ADDENDUM No. 3
FOR
LINK – Multi-Use Development
BID PACKAGE – All Trades

Date of Issue: April 24, 2023

LINK – Addendum #3 Narrative

4/21/23

3 UNIT 2C
S151 1/4" = 1'-0"

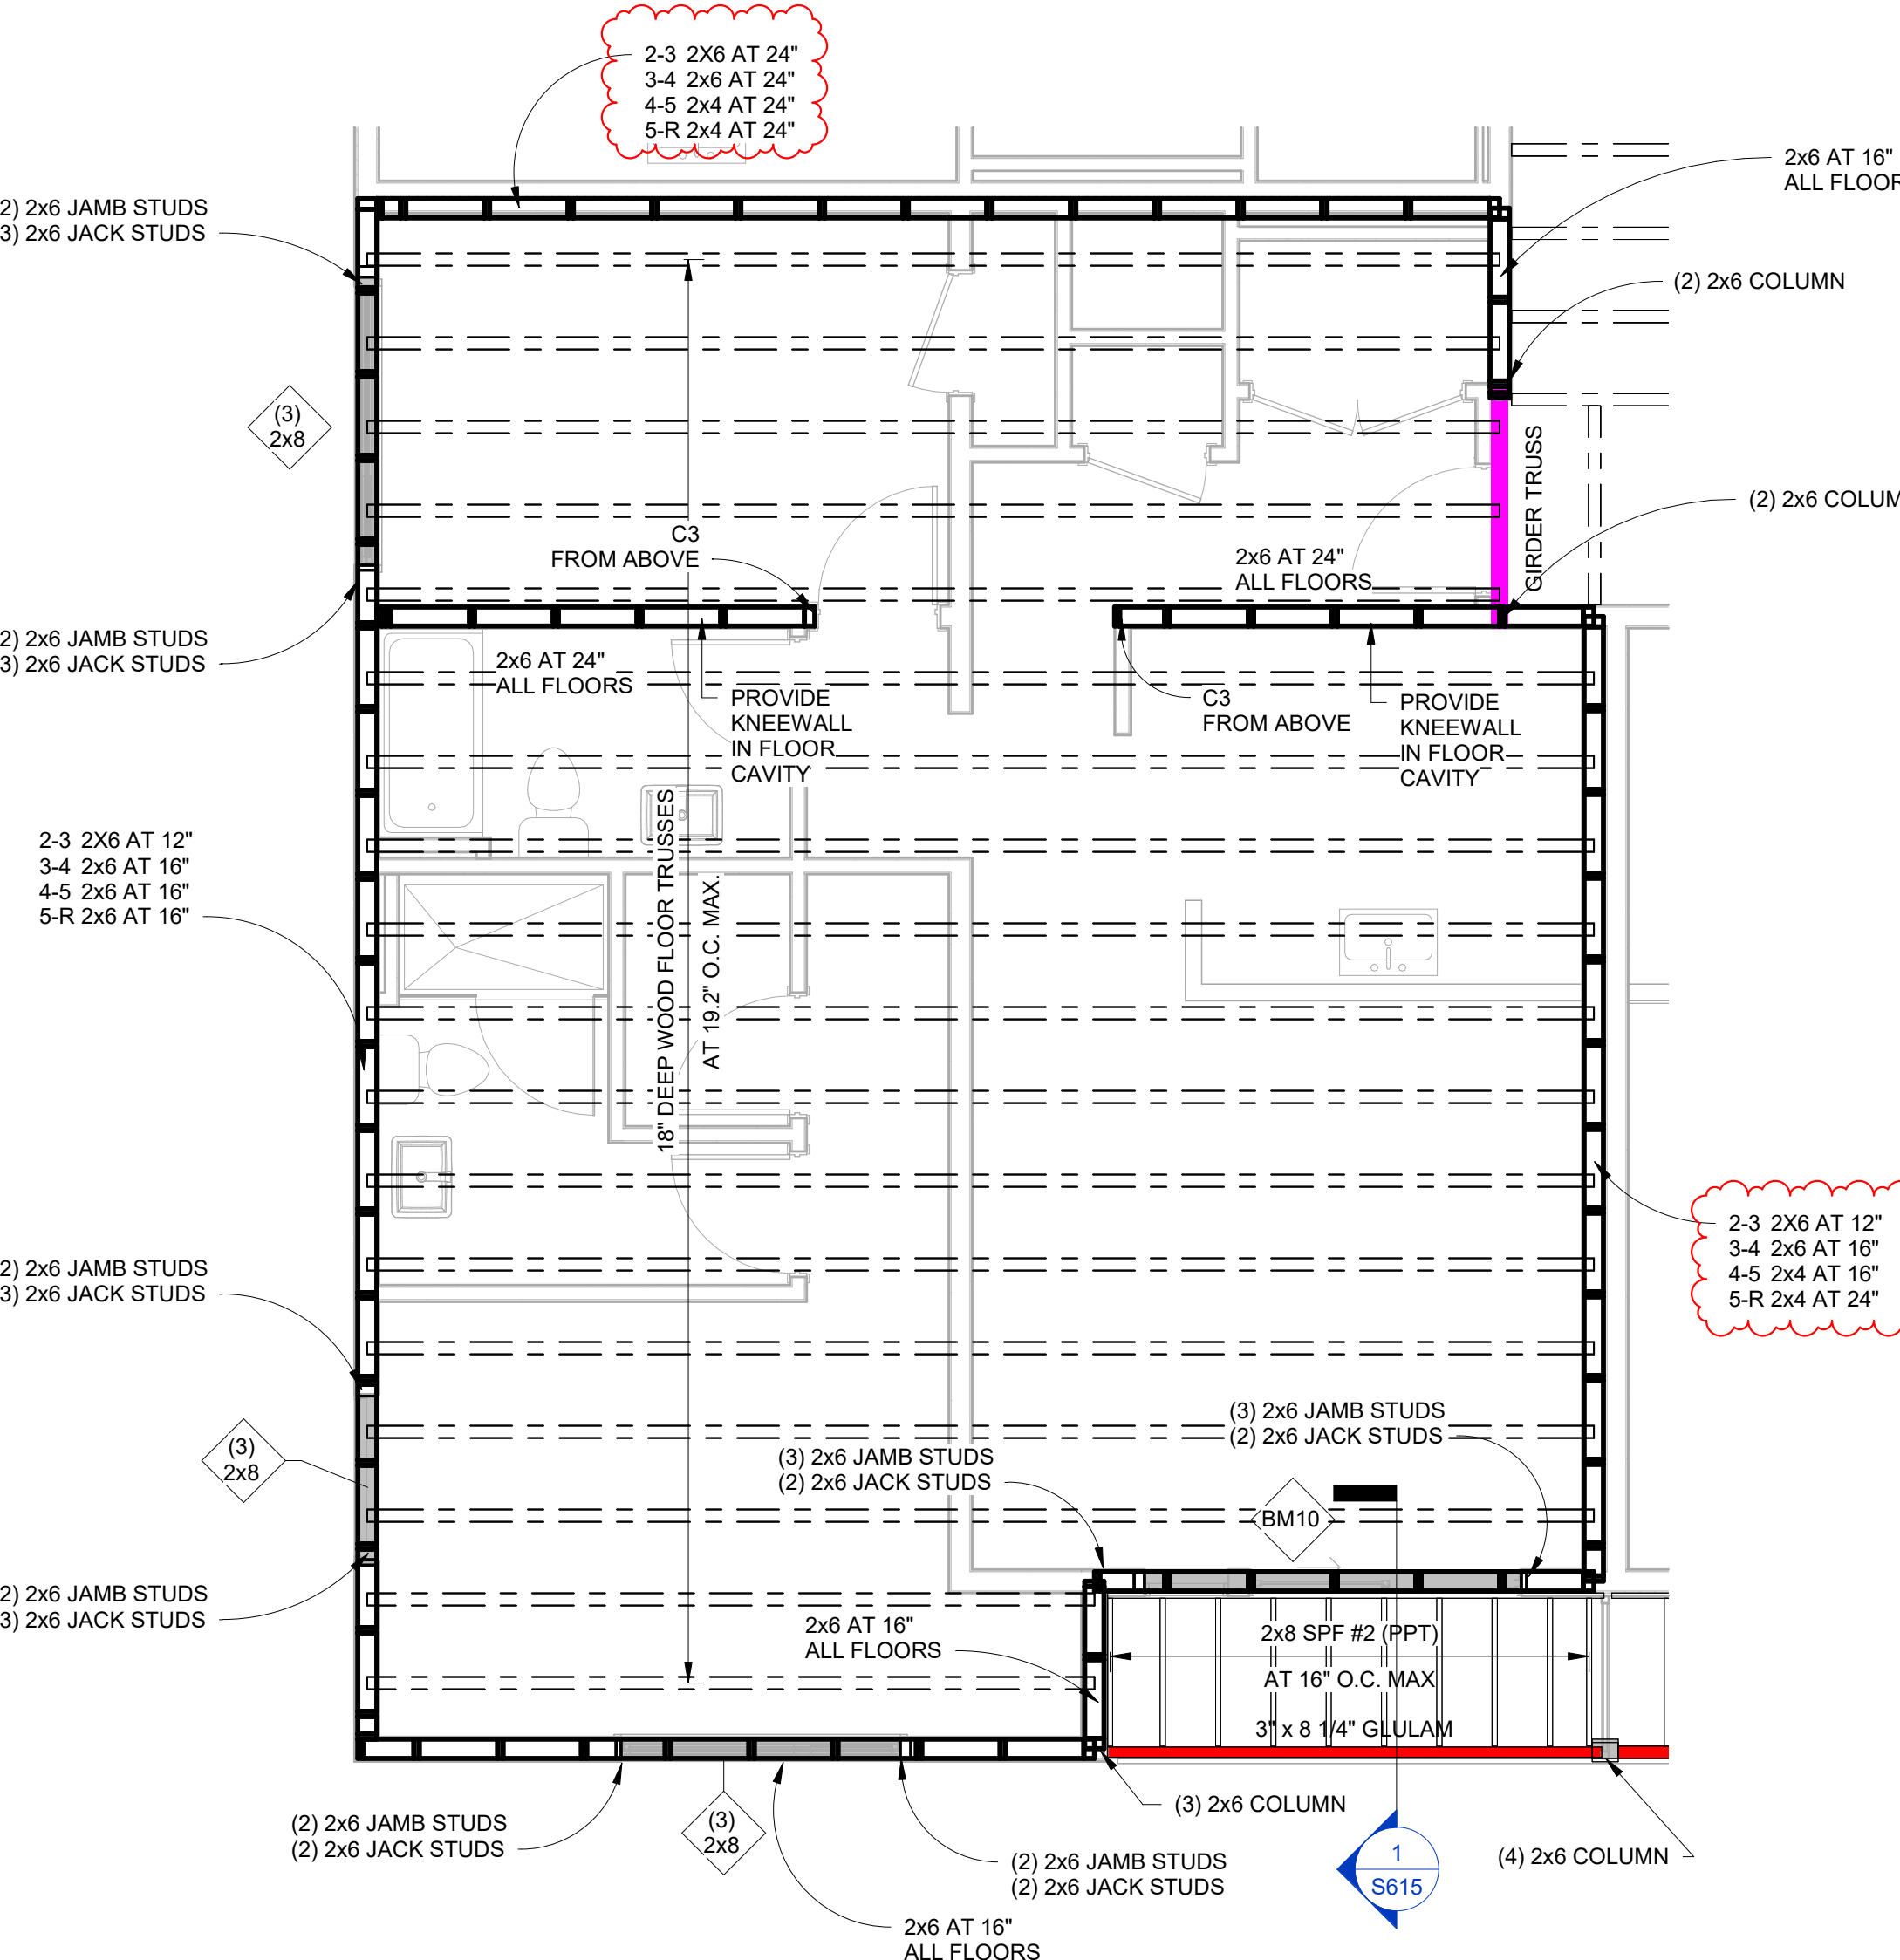
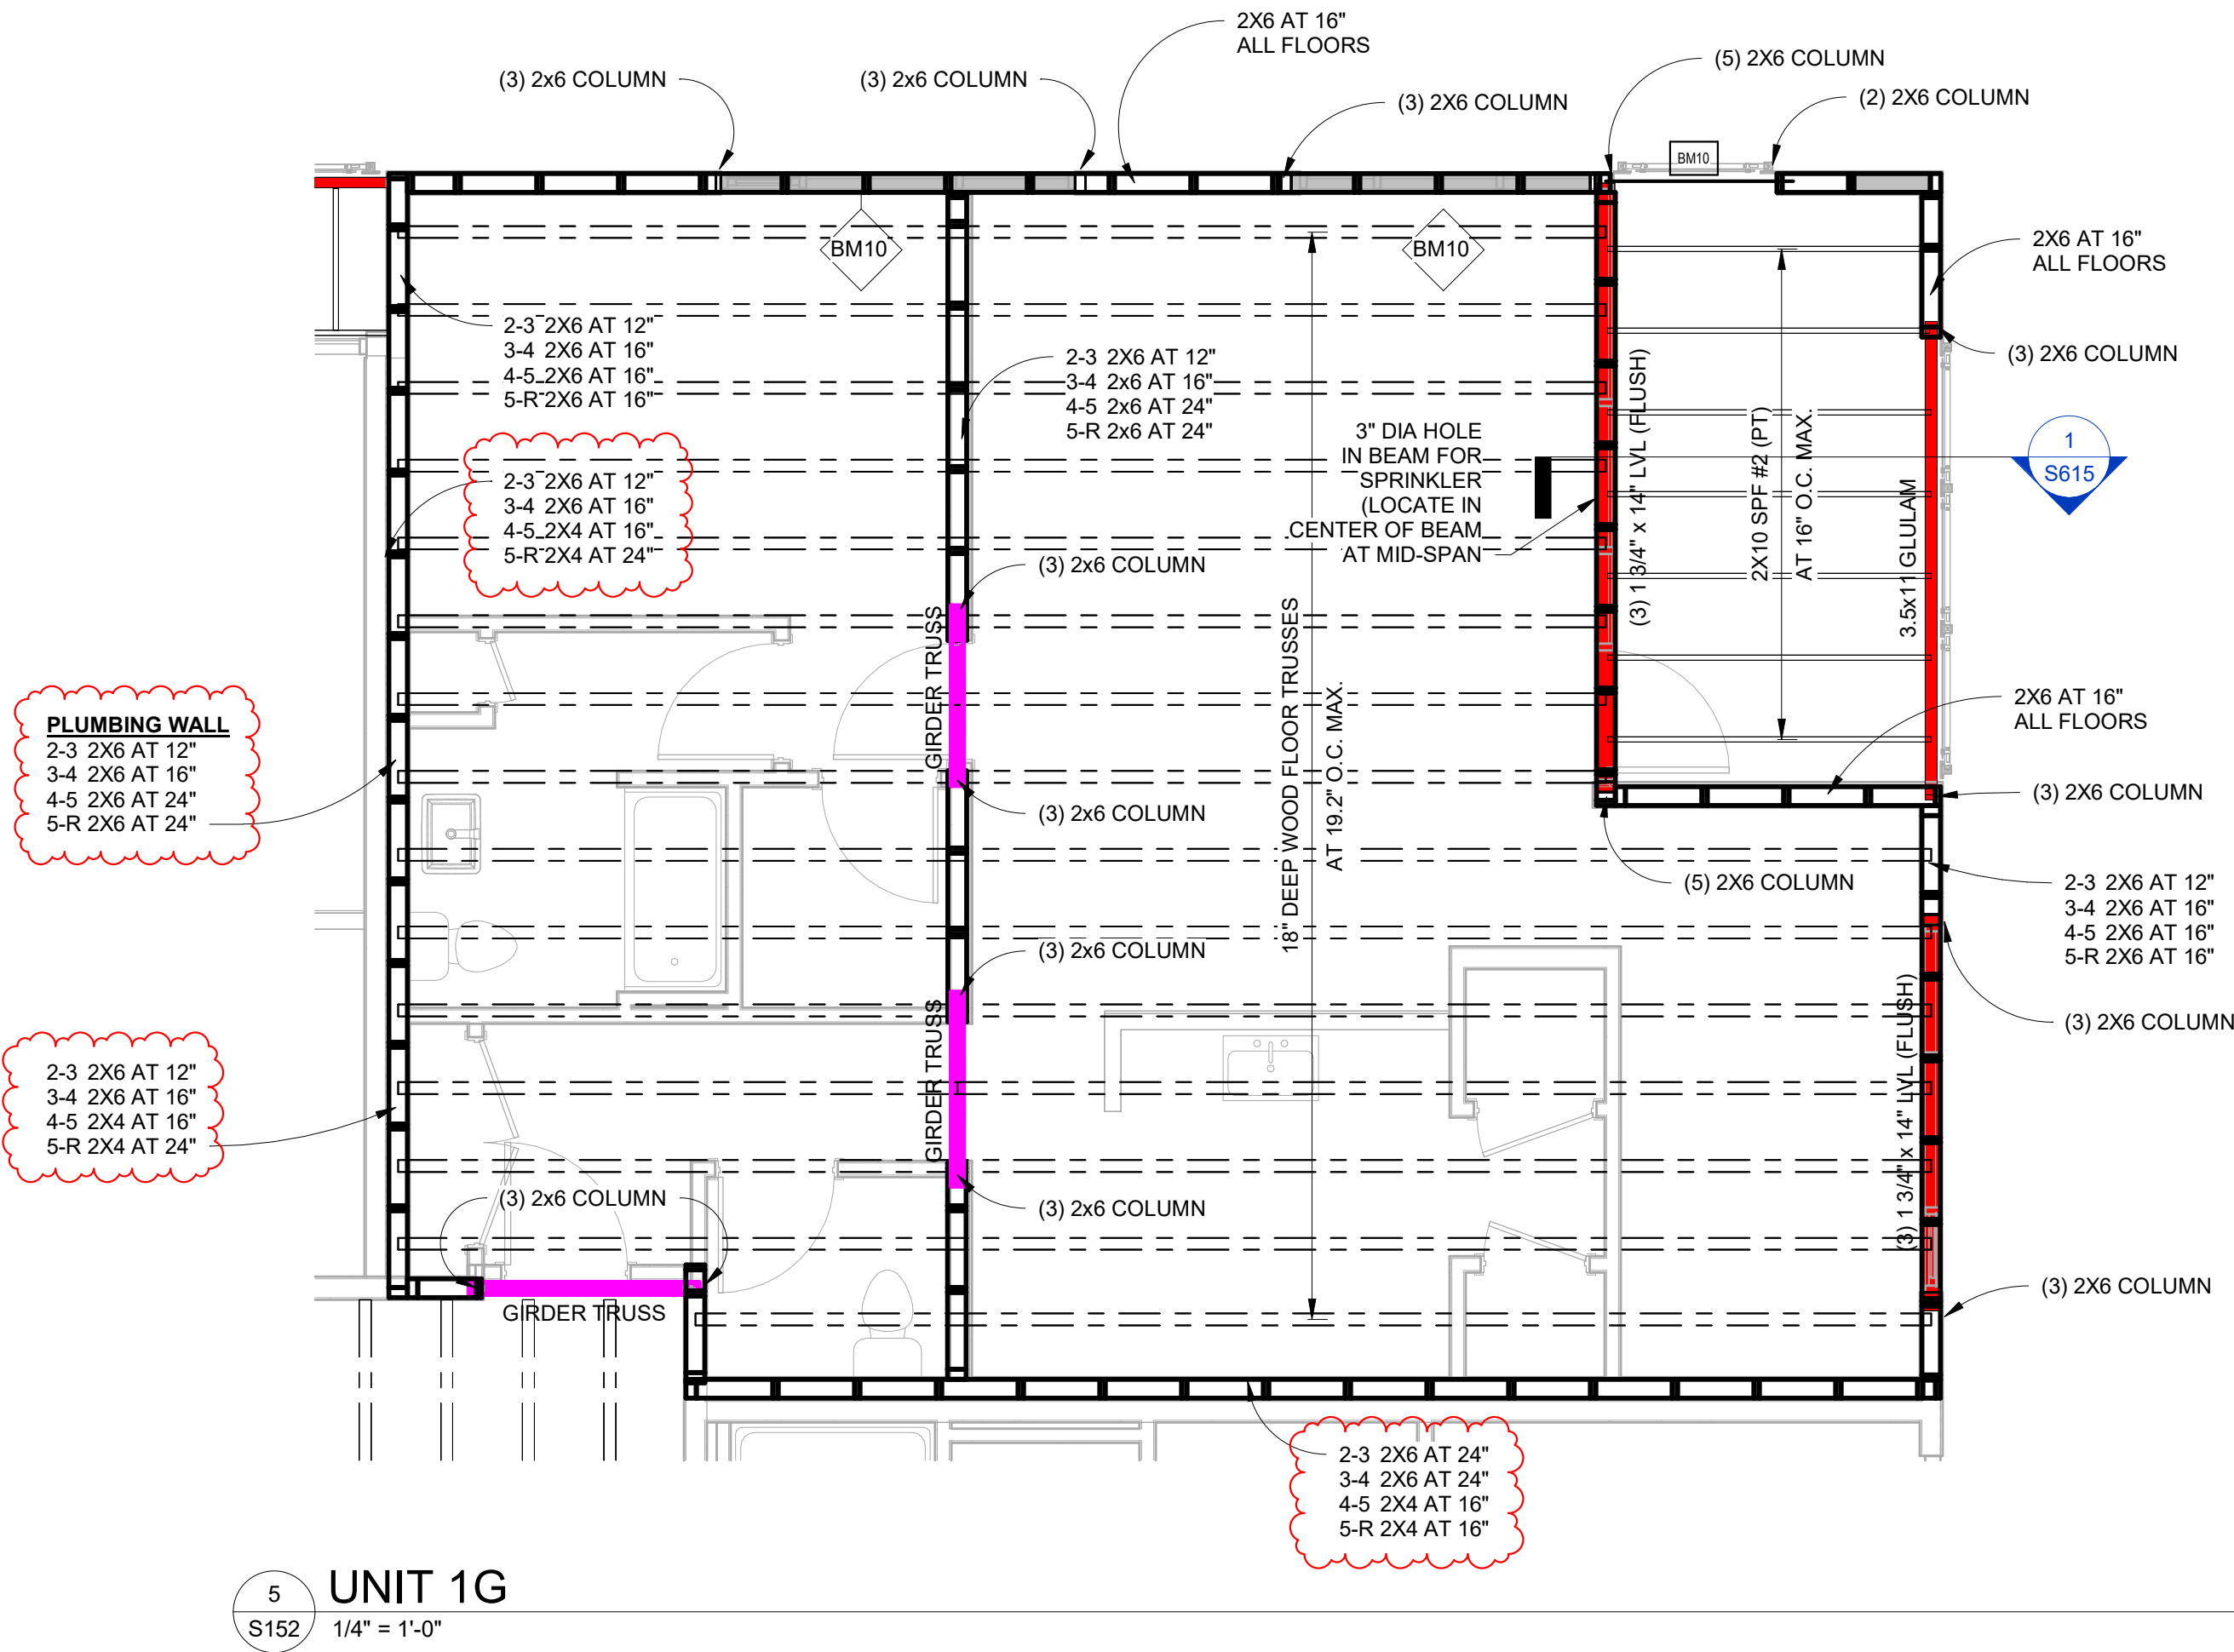
- S150
 - Revised studs at upper floor demising walls to 2x4 studs where indicated.
 - S151
 - Revised studs at upper floor demising walls to 2x4 studs where indicated.
